SprintRay Inc

Declaration of Product Modifications

This is to request a Class II permissive change for FCC ID: 2A96L-SRP2304A originally granted on 06/04/2024

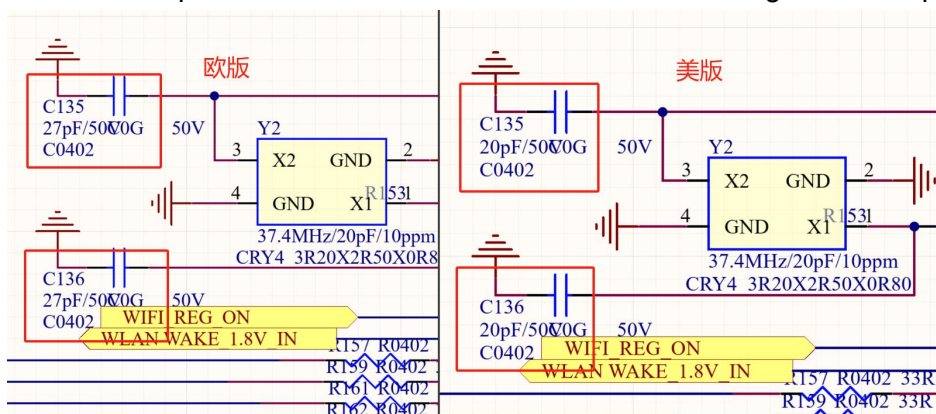
1. The P10 pin of the Ethernet connector is changed from GND to the chassis ground

2. The capacitance values of C135 and C136 are changed from 20pf to 27pf
